Proposed Large-Scale Residential Development,
Sarsfield Road, Wilton, Co. Cork.

COMBINED STAGE 1 & 2 ROAD SAFETY AUDIT

January 2025

Figure 1.2: Proposed Site Layout (Credit: Reddy Architecture + Urbanism)

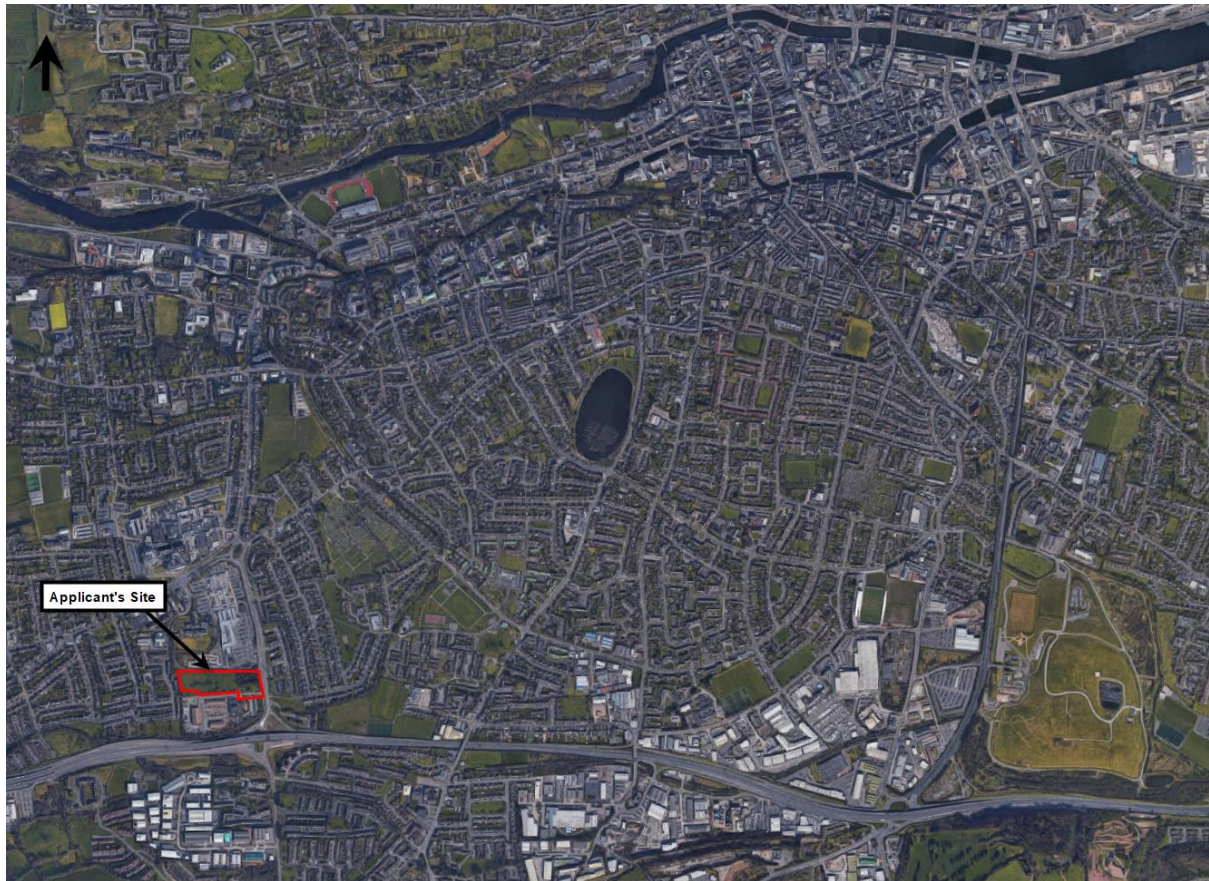
The development proposes a shared pedestrian and cycle access location on the eastern boundary of the site. No ladder and tramline tactile paving is shown at this connection to warn visually impaired pedestrians of the potential hazard. A second occurrence of missing ladder and tramline tactile paving was noted internally within the development where an adjacent pedestrian path connects to the shared surface.

Failure to provide the appropriate warning paving may lead to visually impaired users stepping onto the proposed cycle track which may lead to collisions with cyclists.

The access road serving the proposed residential scheme forms a T-junction from the ESB facility entrance road. The centre line road markings are solid through the development entrance, inferring no vehicular crossing movements should be allowed. Failure to provide appropriate road markings may lead to confusion for drivers at the location and possibly lead to vehicular collisions.

Provide appropriate tactile paving at the connection of footpaths/shared surfaces, in accordance with the relevant design standards and guidelines.

Provide appropriate road markings, in accordance with relevant design standards.
